- SUBJECT: 1. NEGATIVE DECLARATION
2. TENTATIVE MAP TO SUBDIVIDE 7.93± ACRES
INTO 13 LOTS (9 SINGLE FAMILY AND 4 HALFPLEX,
AND ONE 6.64± ACRES REMAINDER LOT) IN THE
R-1 ZONE (P91-070)
3. SUBDIVISION MODIFICATION TO CREATE A LOT LESS THAN 100
FT. DEEP

LOCATION: Strawberry Lane South of John Muir School
Owner: Sacramento City Unified School District
Applicant: Harry Feiler, 7961 La Riviera Drive, Sacramento, CA 95826

TENTATIVE SUBDIVISION MAP
**HIDDEN VILLAGE
UNIT NO. 2**
CITY OF SACRAMENTO MAR 1991

EXHIBIT - A
TENTATIVE MAP

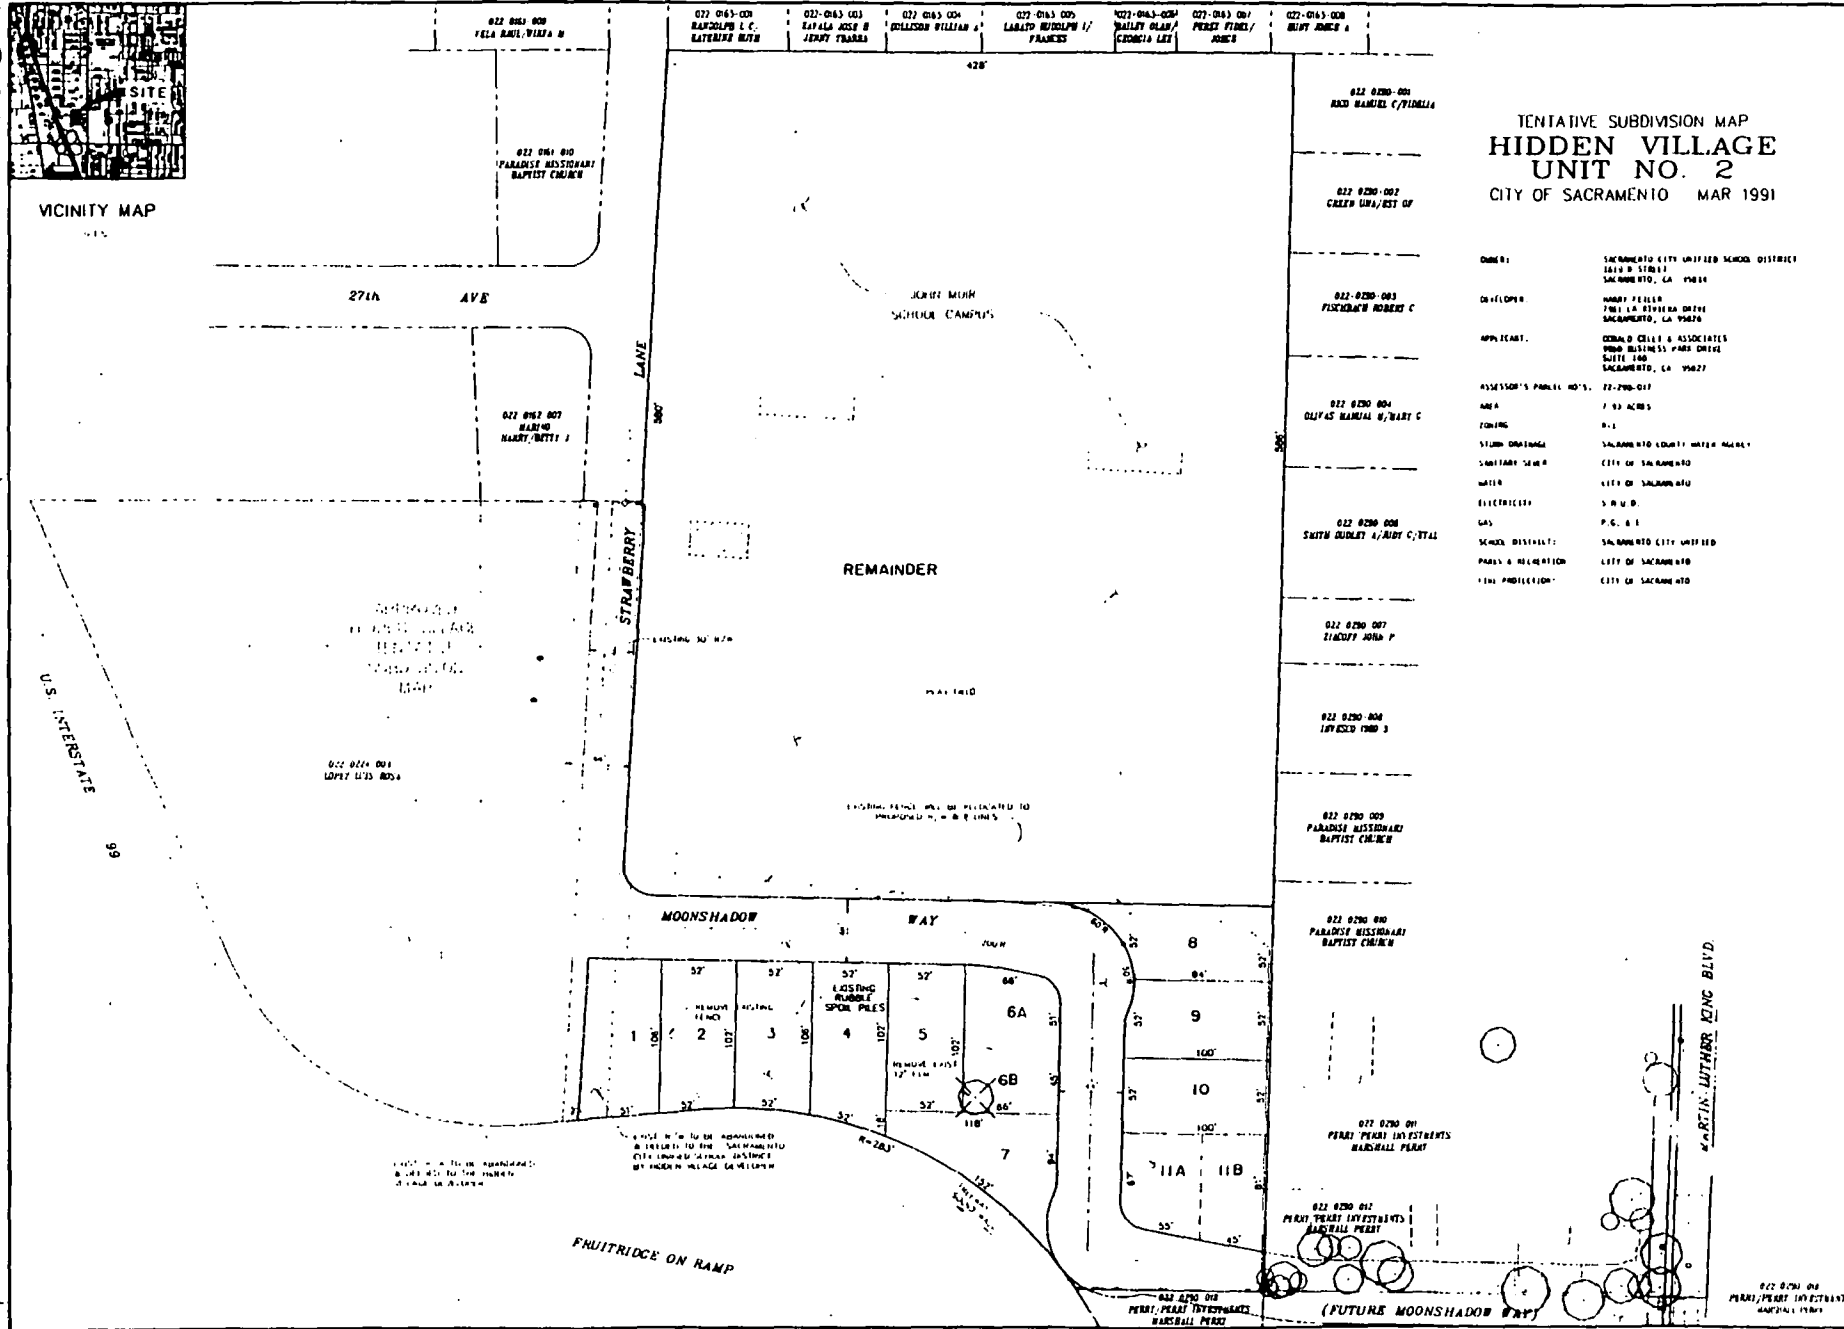
- A. Provide standard improvements pursuant to Section 40.811 of the City Code;
 - B. Prepare a sewer and drainage study for the review and approval of the Public Works Department. Extend off-site water line to provide a loop system for Strawberry Lane to Martin Luther King Jr. Boulevard. It may require off-site sewer and drain extension and oversizing;

- H. Requires off-site dedication along the extension of Moonshadow Way. City will condemn at developer's expense, if necessary. Construct a minimum of 24 feet wide pavements to Martin Luther King Jr. Boulevard;

- I. Construct both elbows of City standards with a 50 foot radius and 30 foot return radius (Note: This will create a fence/property line which is not straight on the southern boundary of the school remainder; and

EXHIBIT - A
TENTATIVE MAP

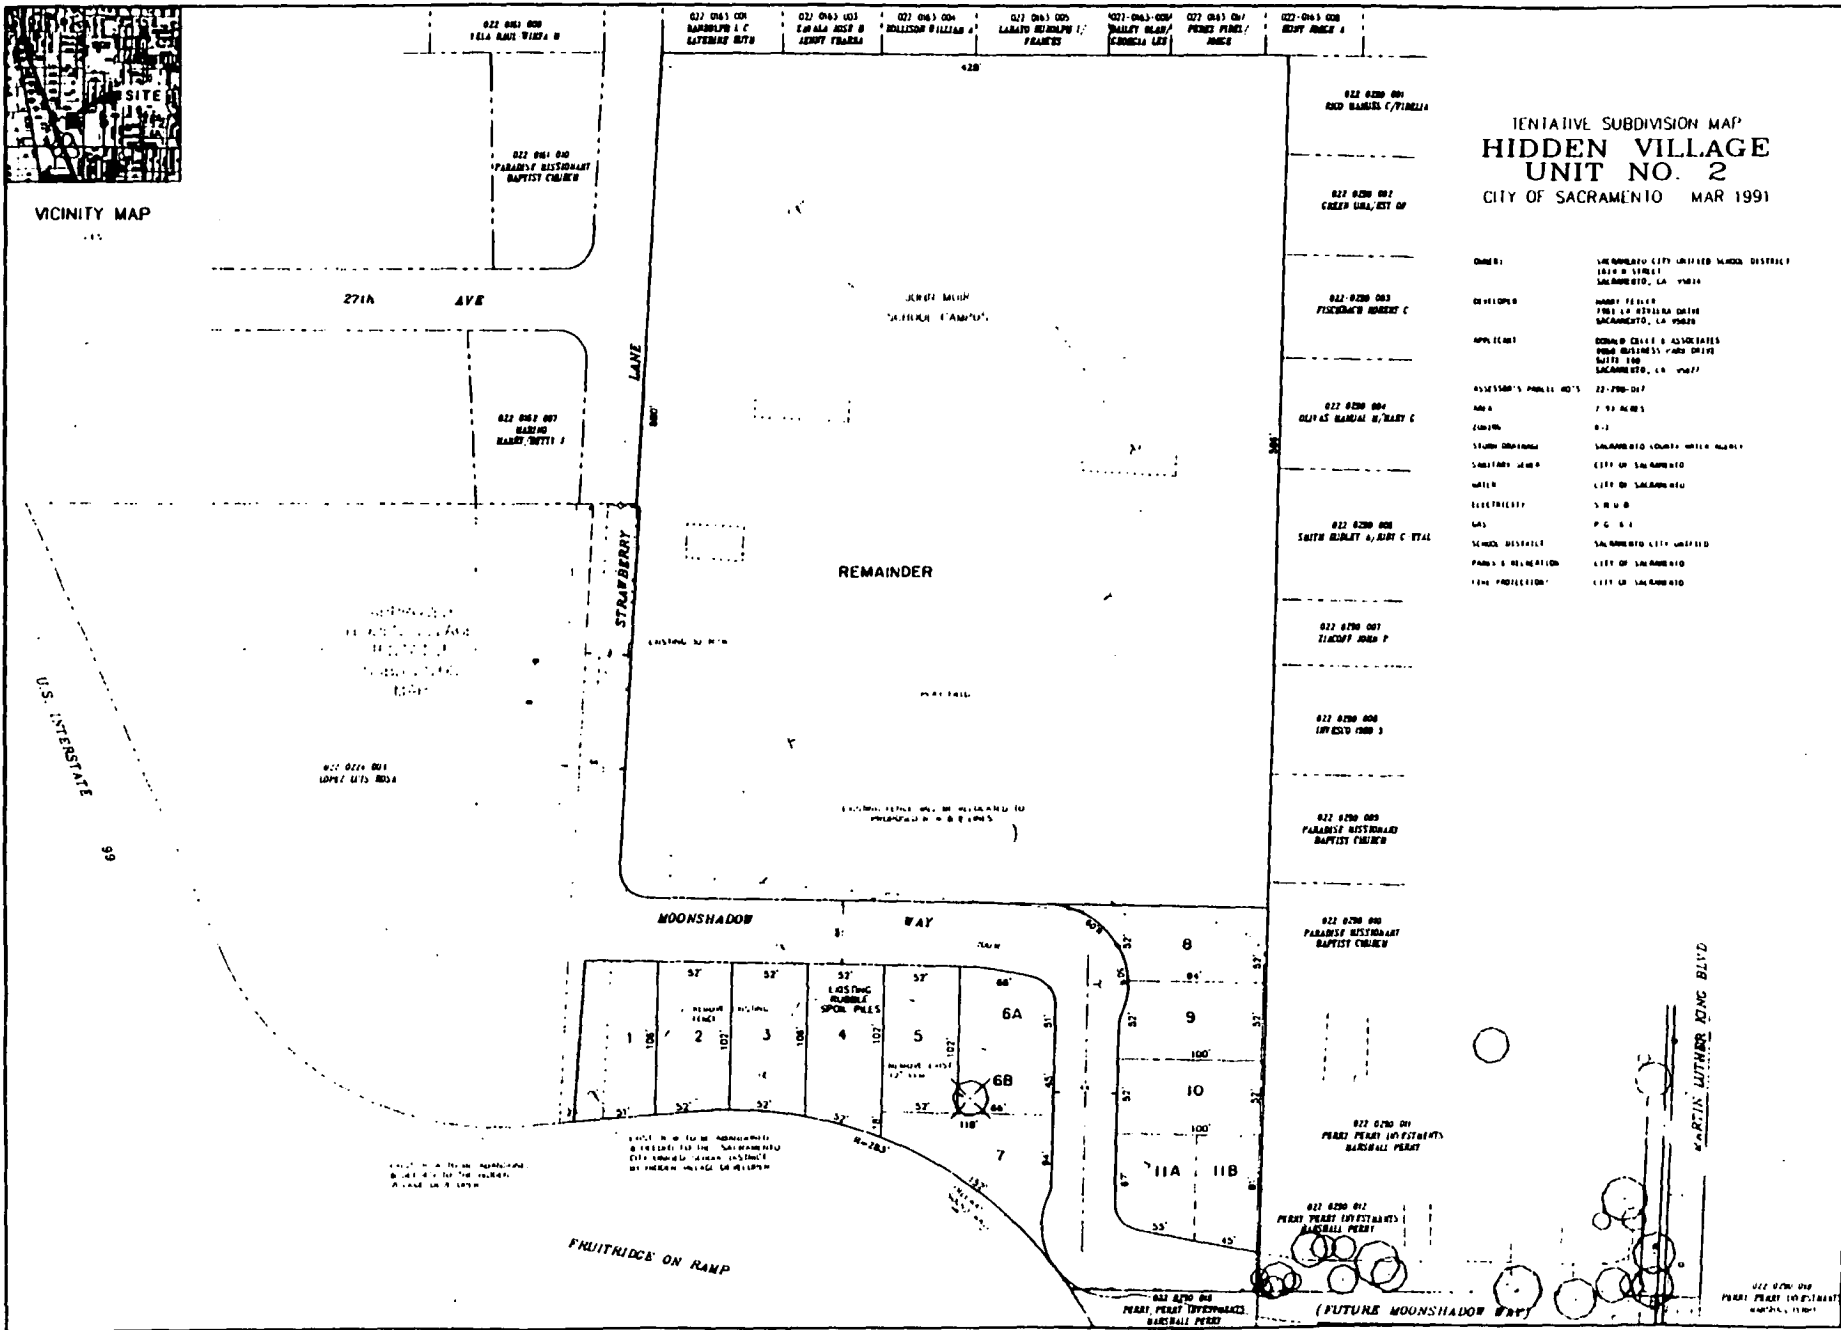
Staff has no objection to the tentative map proposal. The 8.7 dwelling unit per net acre density of this project conforms to the General Plan designation. All but one lot (Lot 9) meets the minimum requirements of the Subdivision Ordinance. This lot, however, is suitable for development of a standard single family residence without requesting any setback variances. The tentative map ties into Hidden Village Unit No. 1 and allows for future connection to Martin Luther King Jr. Boulevard.

2. Prepare a sewer and drainage study for the review and approval of the Public Works Department. Extend off-site water line to provide a loop system for Strawberry Lane to Martin Luther King Jr. Boulevard. It may require off-site sewer and drain extension and oversizing;

8. Requires off-site dedication along the extension of Moonshadow Way. City will condemn at developer's expense, if necessary. Construct a minimum of 24 feet wide pavements to Martin Luther King Jr. Boulevard;

9. Construct both elbows to City standards with a 50 foot radius and 30 foot return radius (Note: This will create a fence/property line which is not straight on the southern boundary of the school remainder; and
